Bayside Amendment C157

New Street Estate, Brighton

Expert Urban Design Evidence

Mark Sheppard

Design Framework - Proposed Internal Connections (Design Framework – Baumgart Clark Architects)

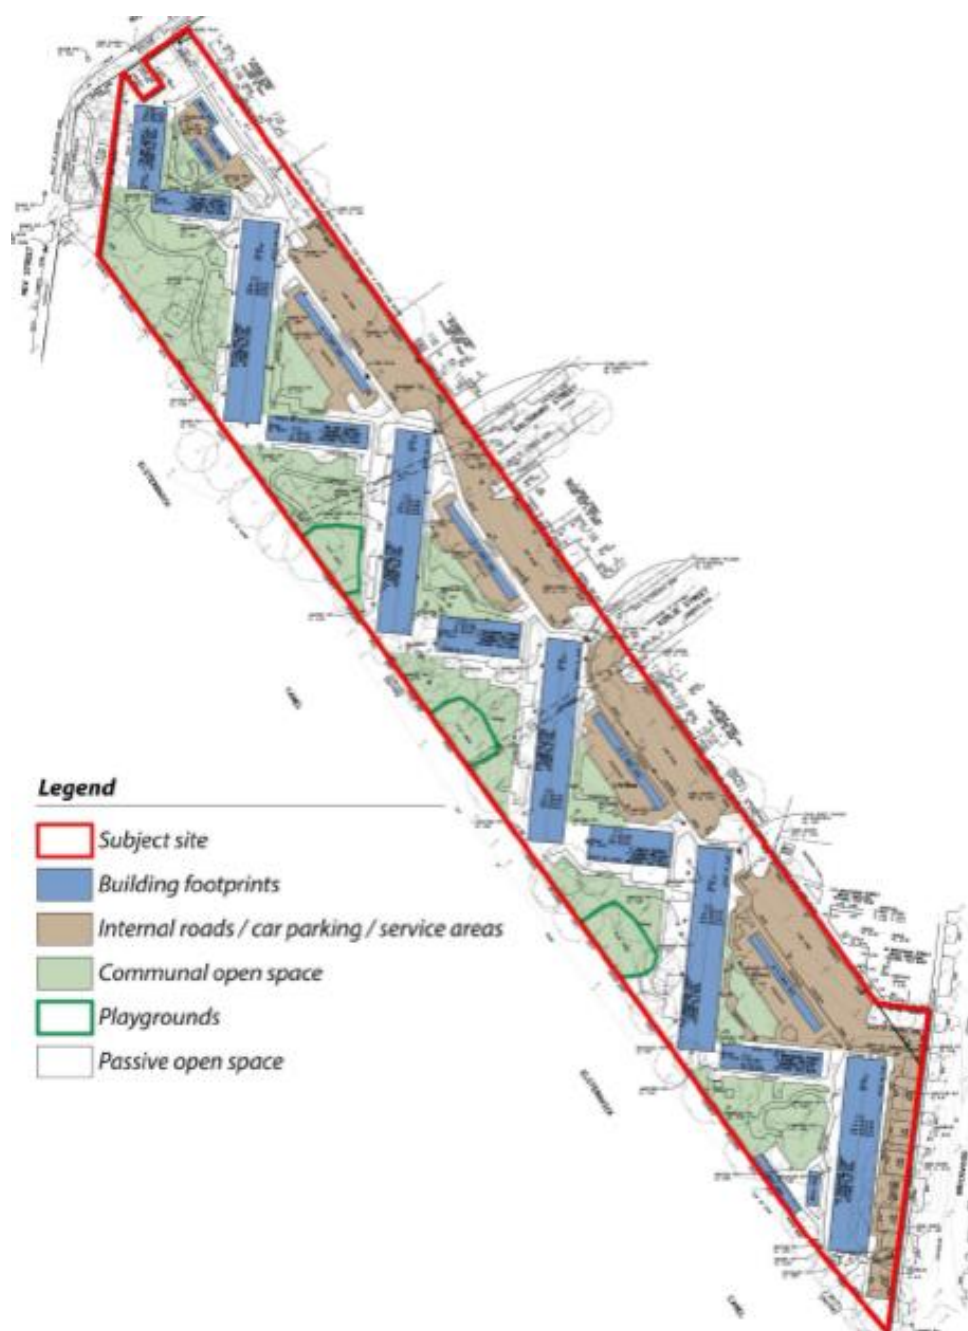
- [53] I understand that the reason that the Design Framework does not propose a path alongside the creek is due to the challenge of accommodating it within the Subject Land, given its narrow width. However, I consider that a public thoroughfare should be provided along the edge of the creek reserve, if possible. It would not significantly enhance the permeability of the broader area, given the presence of the Elster Canal Path on the other side of the creek and the pedestrian bridge at Brickwood street. However,

it would help to integrate the Estate with the surrounding area because it would increase the number of people passing alongside it and give the proposed pedestrian links through the Estate from Salisbury and Airlie Streets more purpose. It would also improve access to the proposed new public open space centrally located along this interface, and provide a more convenient route to the Rusden Street bus stop for residents of the Estate.

- [54] The creekside thoroughfare should be fronted by development to ensure that it is an inviting and safe pedestrian and cycle path. It need not be a vehicular route. There appears to be sufficient level land for the path at the northeastern edge of the creek reserve for most of its length. However, it may need to be partly or wholly within the Subject Land in places due to the proximity of the embankment to the boundary.

- [55] Provided an inviting path is created along the creek interface, it is not necessary to have the proposed public connection through the middle of the Estate from Rusden to Brickwood Streets. This would allow the latter to be retained purely for private access to communal open spaces, avoiding concerns about its changes of level.

- [56] In summary, I consider that the proposed movement network should incorporate a public thoroughfare along the interface with the creek reserve because it will enhance integration and access to the proposed new public open space. This renders the currently proposed internal link between Rusden and Brickwood Streets unnecessary from a public permeability perspective.

Design Framework – Proposed open space (Baumgart Clark Architects)

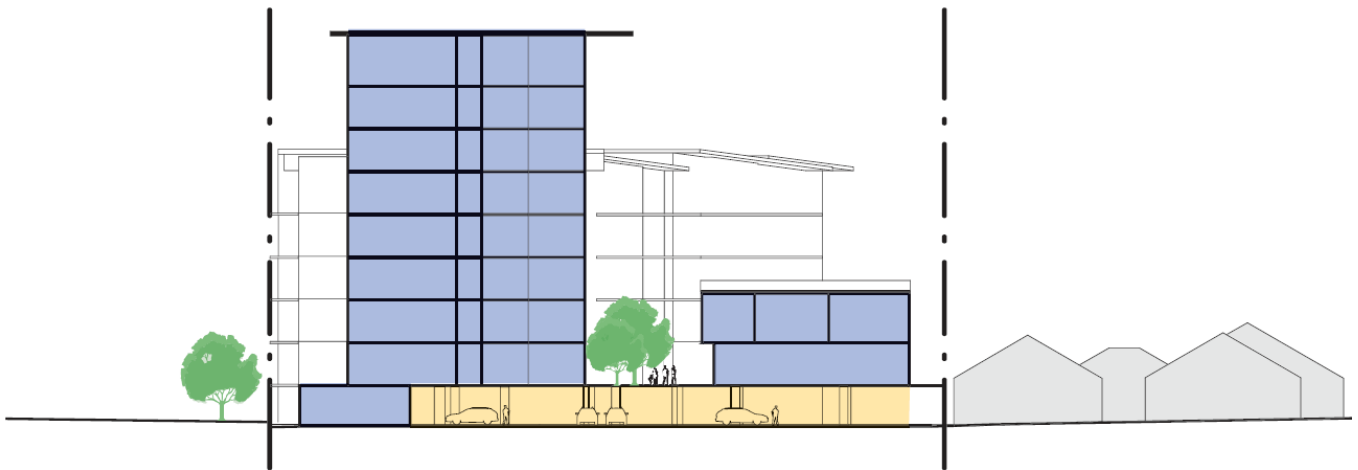
- [62] The Design Framework proposes the creation of one 2,230m² pocket park centrally within the Subject Land alongside the creek reserve, accessed via new pedestrian links extending Salisbury and Airlie Streets. This location maximises accessibility for future residents of the Estate, and enables the retention of a number of trees of high and medium retention value. The creation of a single consolidated open space will enable it to accommodate a wide range of activities and uses, in accordance with the Urban Design Guidelines for Victoria (Guideline 3.4.1b).

- [63] The pocket park is well framed by buildings and edged by building frontages, providing good spatial definition and passive surveillance. It will also contribute to placemaking by creating a memorable place within the Estate—particularly given its outlook over the creek—which would be enhanced if a public path is created along the creek edge.

- [64] The park has an odd-shaped finger extending south from its eastern corner. The purpose of this finger of open space is not clear.
- [65] The area of the proposed new open space is approximately 1,510m² (or 40%) less than the area of communal open space which currently exists on the Estate. There is no directly-applicable standard for the provision of open space in urban renewal areas such as this. However, I note that the proposed park is 16% of the total site area (14,130m²), which far exceeds the standards for public open space in a subdivision (5%) and growth areas (10%). It is also over 7m² per dwelling, which far exceeds the communal open space requirement of clause 58.03-2 of 2.5m² per dwelling or 250m², whichever is the lesser. Given this, and the Estate's proximity to Elsternwick Park, I consider that its size is more than sufficient.

- [67] I also note that there is proposed to be informal communal open space on top of the parking podia between the buildings.
- [68] I support the way in which the proposed new open spaces are well defined by surrounding buildings, and generally well surveilled by them, contributing to the 'normalisation' of the Estate.

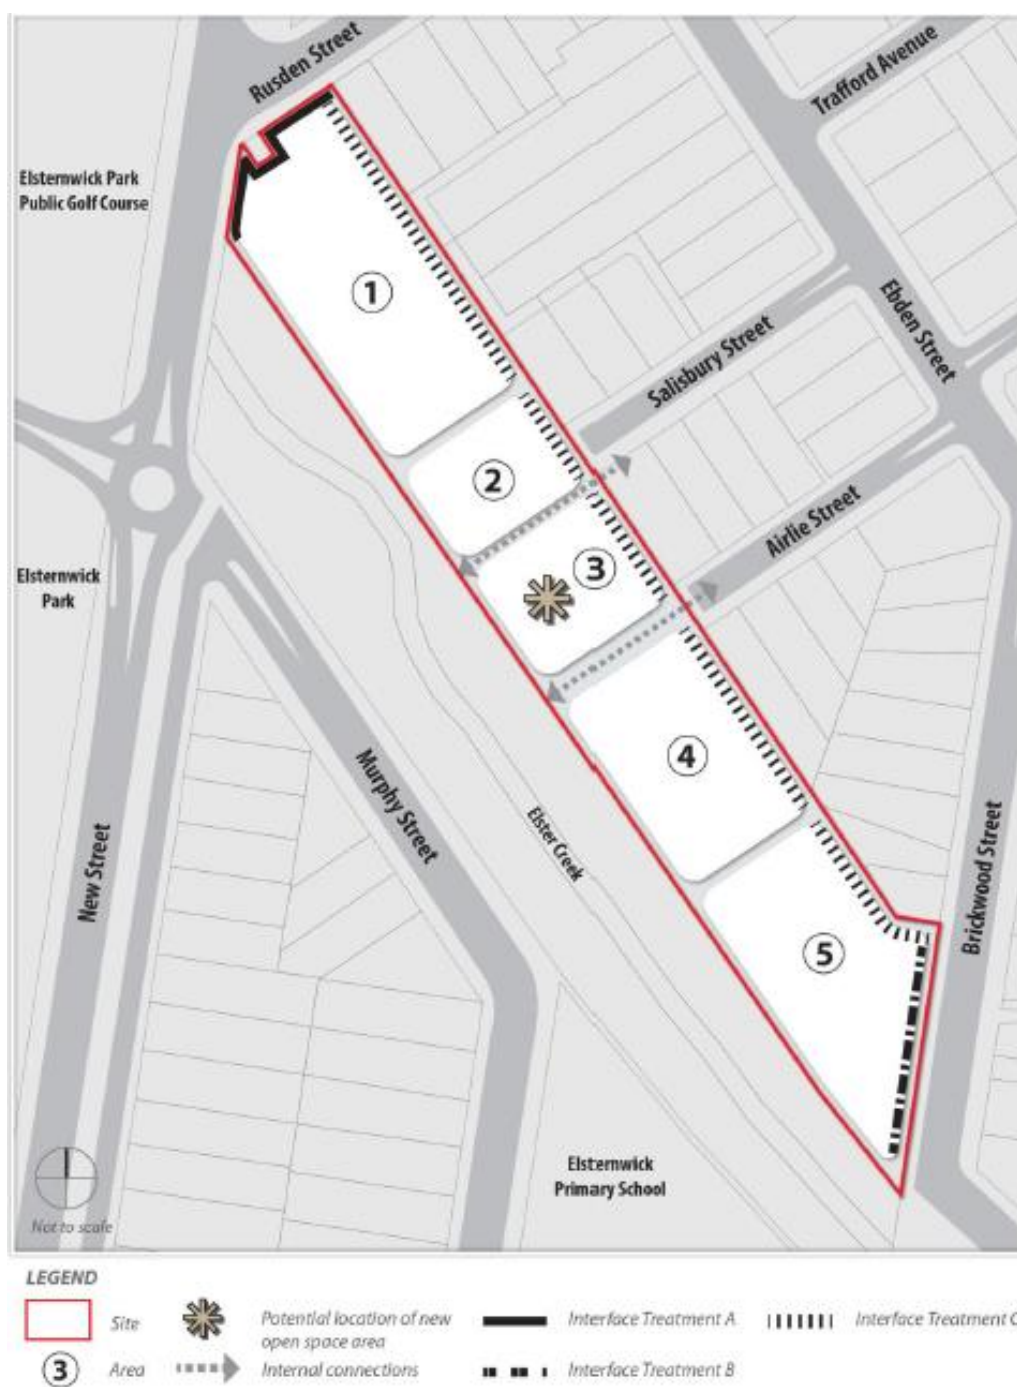
[92] The internal connections illustrated by the Development Concept Plan are generally consistent with the two proposed by the Design Framework that I support. However, I consider that the northern connection should be adjusted to connect more directly with Salisbury Street.

[93] The Development Concept Plan does not show a connection along the creek frontage. However, the schedule encourages a development plan to show or make provision for the connections referred to above to *'connect with a new publicly accessible pedestrian path provided along Elster Creek between New and Brickwood Streets'*.

[94] As noted in section 4.1, I consider that a public path along the creek frontage is critical to the success of the future development of the Estate. I consider that a development plan should not only provide for connections to such a path, but make provision for the path itself, even if it is partly or wholly within the creek reserve.

1. Amend the Development Concept Plan to show the northern internal connection aligned more directly with Salisbury Street.
2. Amend the Development Concept Plan to show a public path along the Elster Creek interface.

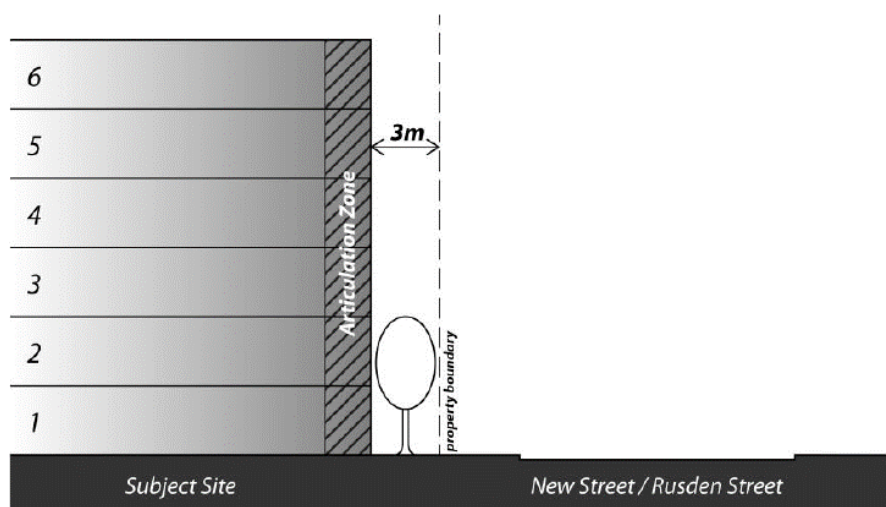
^[105] The schedule defines five areas within the Subject Land and contains a maximum height for each of them ranging between 3 and 9 storeys. The overall maximum building heights are generally consistent with the Design Framework.

^[106] However, as outlined in section 4.4 above, I consider it unlikely that buildings above 6 storeys would be acceptable within the Subject Land. Therefore, I recommend that the areas on the Development Concept Plan be reconfigured into:

- a 3-storey area alongside the northeast boundary,
- a 4-storey area at Brickwood street, and
- a 6-storey area on the balance of the Subject Land.

^[107] The 3-storey area along the northeastern boundary should be approximately 18m wide, so that it is consistent with Interface Treatment C. The 4-storey area on Brickwood Street should be approximately 20m wide, so that it is consistent with Interface Treatment B.

7. Reconfigure the areas within the Development Concept Plan and the associated maximum height table to create:
 - a 3-storey area alongside the northeast boundary, approximately 18m wide;

- a 4-storey area at Brickwood street, approximately 20m wide; and
 - a 6-storey area on the balance of the Subject Land.
8. Amend the development plan requirement for new canopy trees to include the Elster Creek reserve alongside the Subject Land.

Proposed DPO3 Interface Treatment B

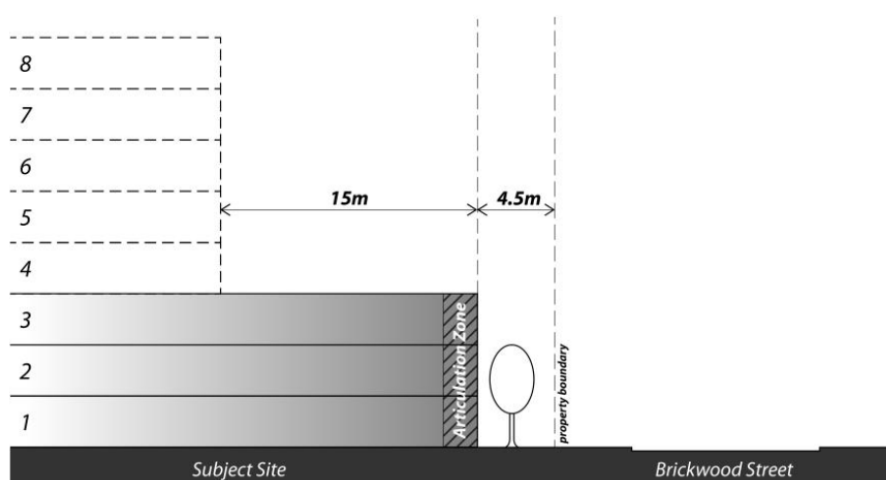
- [114] Interface Treatment B illustrates a 3 storey built form presentation to Brickwood Street, set back 4.5m to an articulation zone, with additional levels set back a further 15m. This matches the Design Framework.

- [116] The schedule also requires a development plan to protect existing trees assessed '*as having moderate or high retention value, unless it is demonstrated that their retention significantly affects the feasibility of development of the relevant precinct*'. The Design Framework illustrates that the medium retention value trees along this interface can be retained.

- [117] The survey plan indicates that the existing building at this interface is set back approximately 7-8m. The existing tree canopies spread across this setback. Therefore, I recommend that the setback in Interface Treatment B be increased to 7m.

9. Increase the street setback in Interface Treatment A to 4m.
10. Increase the street setback in Interface Treatment B to 7m and amend the section to show a fourth level set back a further 2m from those below.
